Lee County Board Of County Commissioners Agenda Item Summary

Blue Sheet No. 20040083

ACTION REQUESTED: Provide direction to DOT staff in regards to the type of structure to be designed for the replacement of the Sanibel Bridges.

PIER TYPE 15B

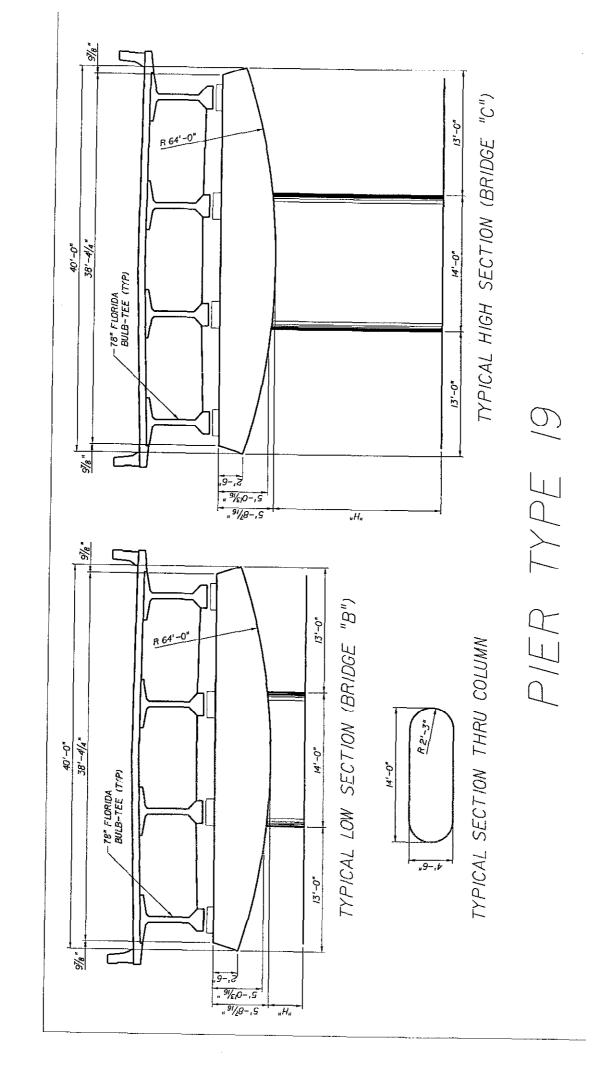
At the January RLAC meeting, the committee reviewed all the options that had been compiled up to that point in time. The RLAC approved a motion to select the pier type shown as Pier Type 15B, the bridge type using the prestressed girders (3 Bulbtee) and the open type railing.
